**Addendum No. 2
to the
Contract Documents
Equipment Storage Buildings Project**

Project No.: 4014

Addenda 02 with responses to Questions from Bidders:

PROJECT: JWCD Equipment Storage Building
5800 S. Bangerter Highway
Taylorsville, Utah 84129

G001

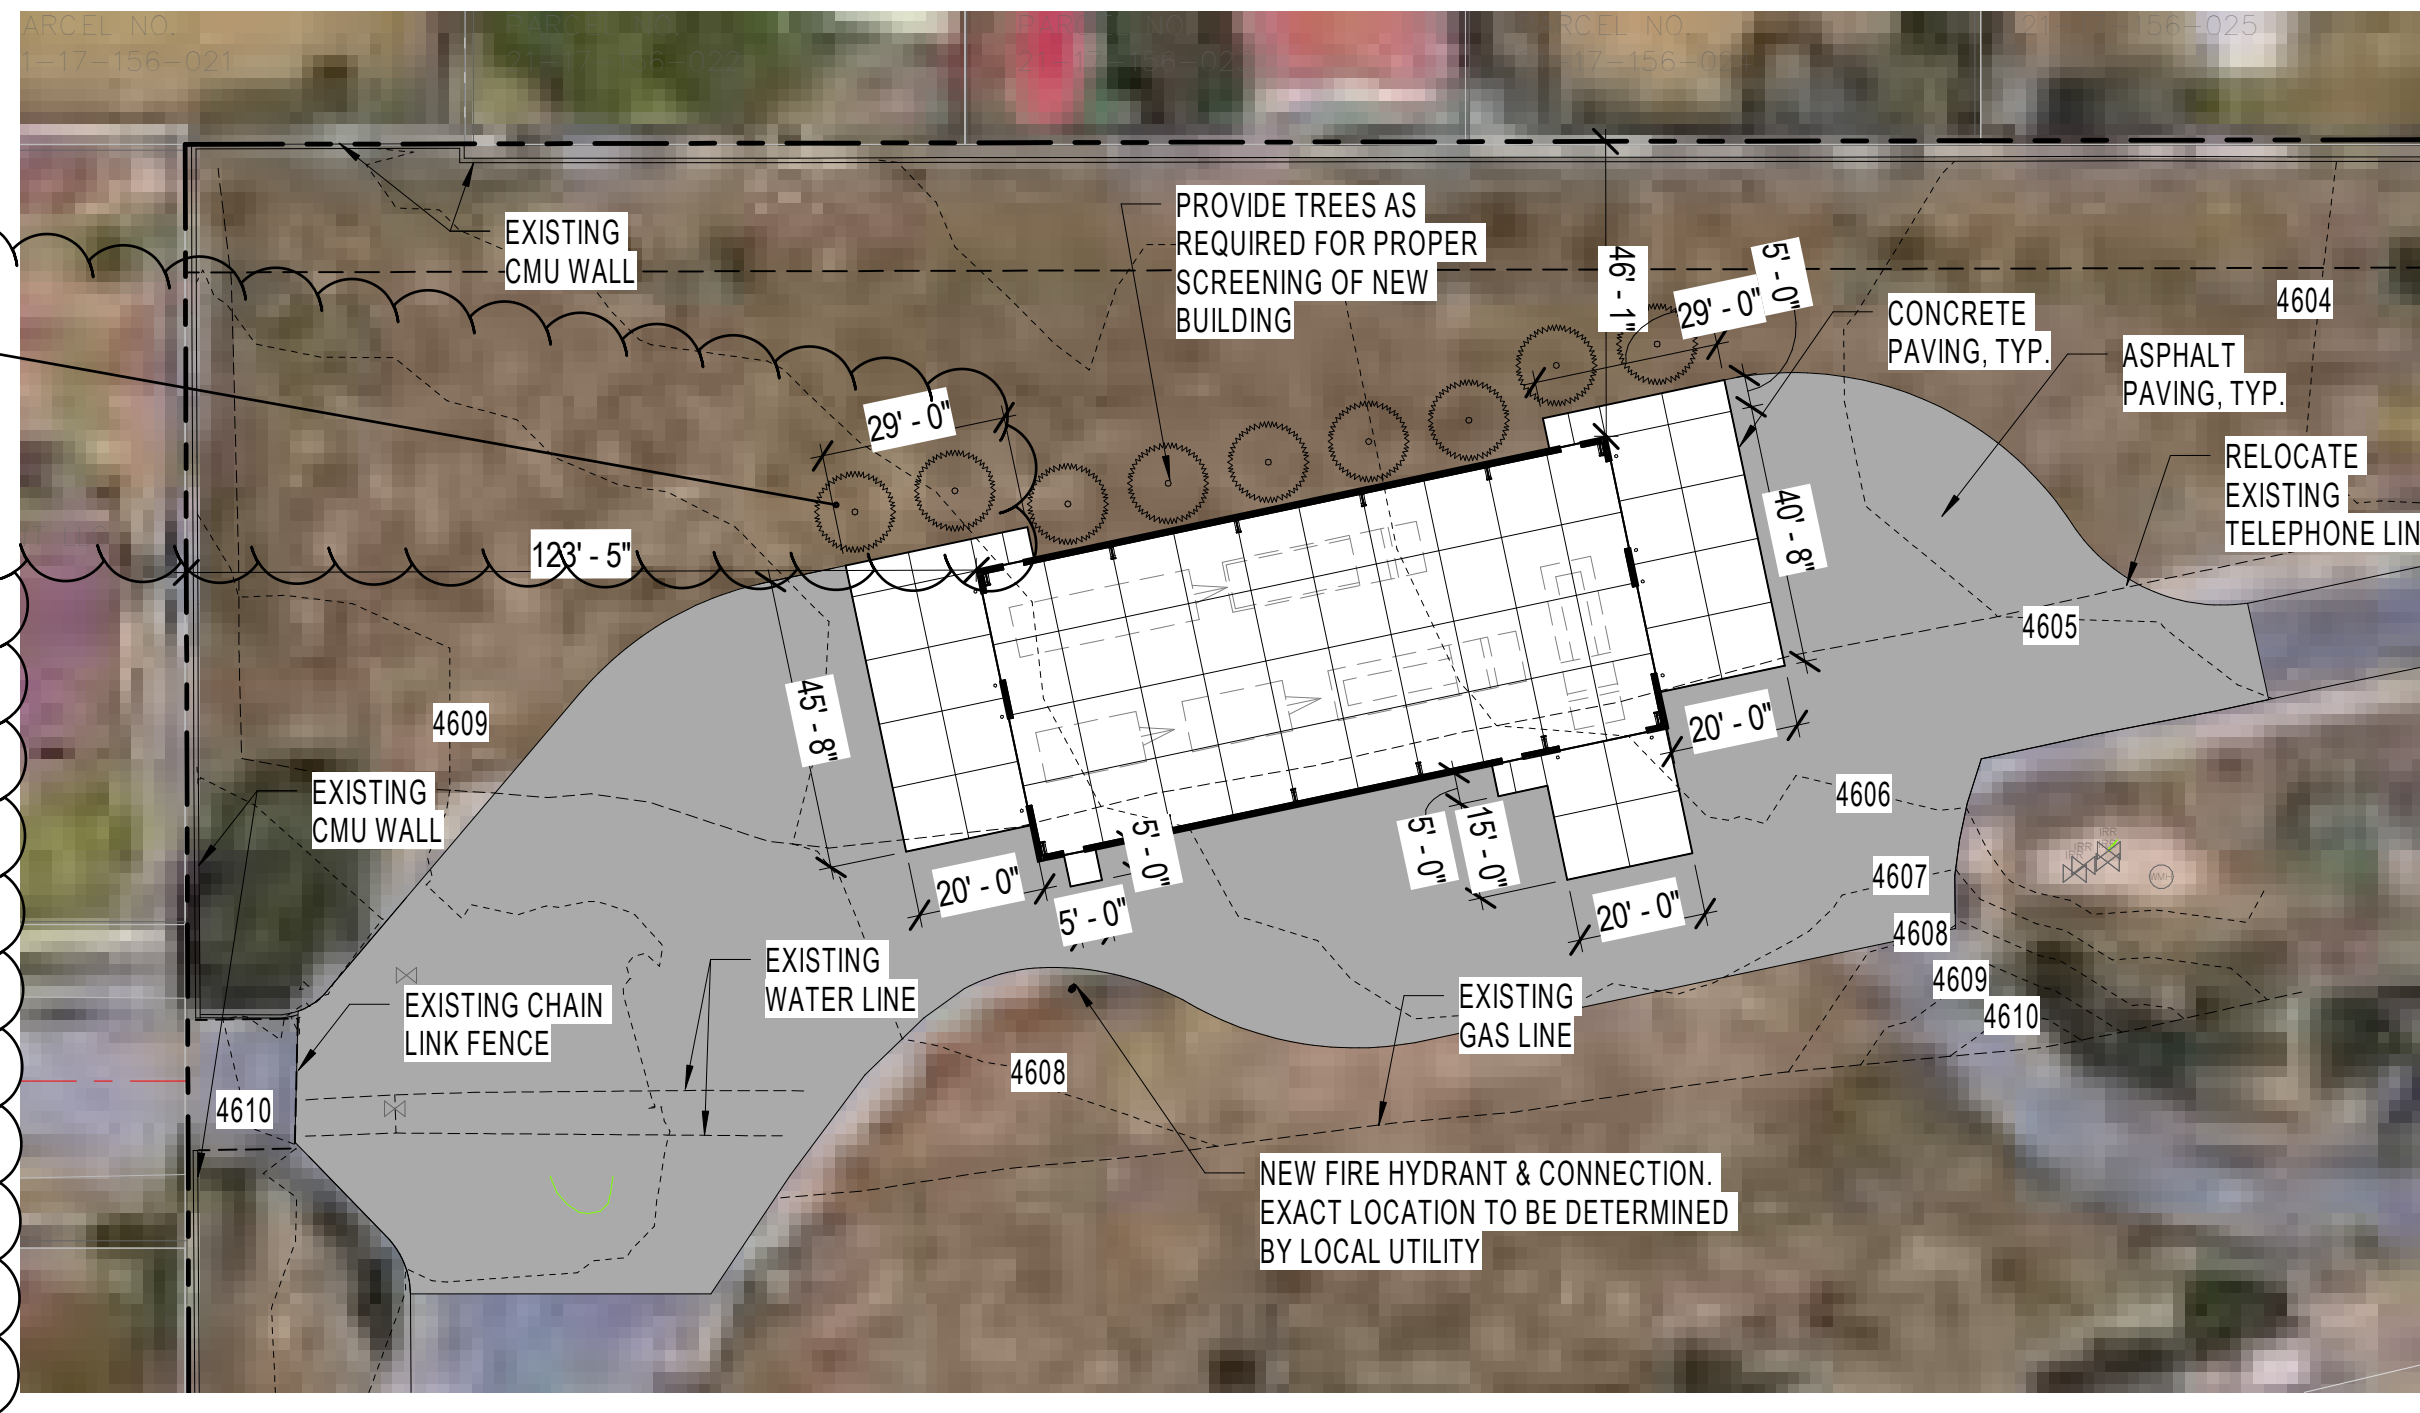
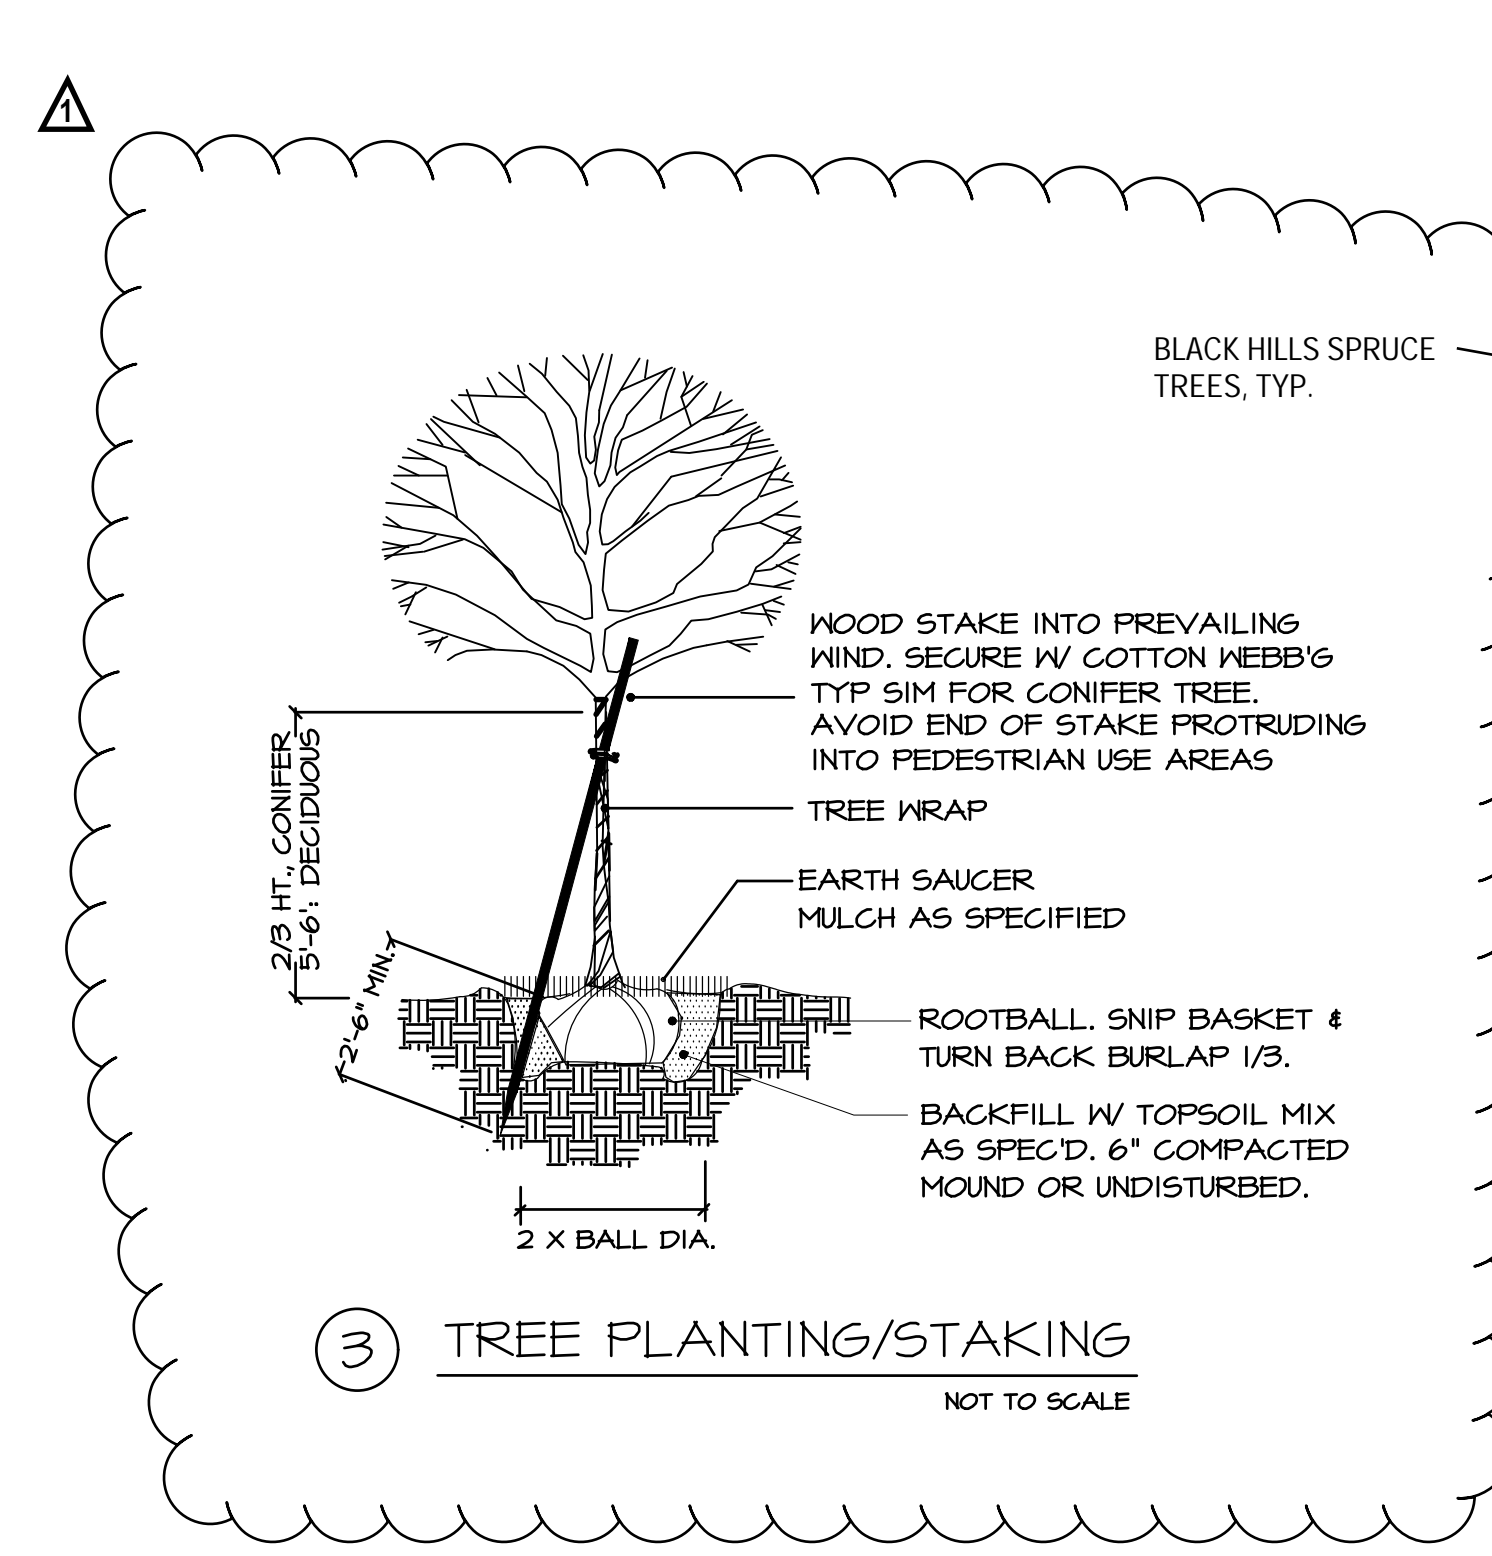
Q5: *On the previous job, I believe we had a landscape plan. I cannot find any information about the type and size of the trees. Currently, the foliage on the trees measure 12' diameter which is a very expensive tree. Please clarify. Also, I do not see any other ground cover such as grass except for the drainage rock on the back of the building. It seems that for the area this project is located that there would be more detail on the landscaping.*

Response: The 12' diameter foliage on the evergreen trees are shown at full maturity. The trees are to be Black Hills Spruce trees. Sheet G001 has been updated with this information. Note: landscape irrigation will be design-build by the general contractor.
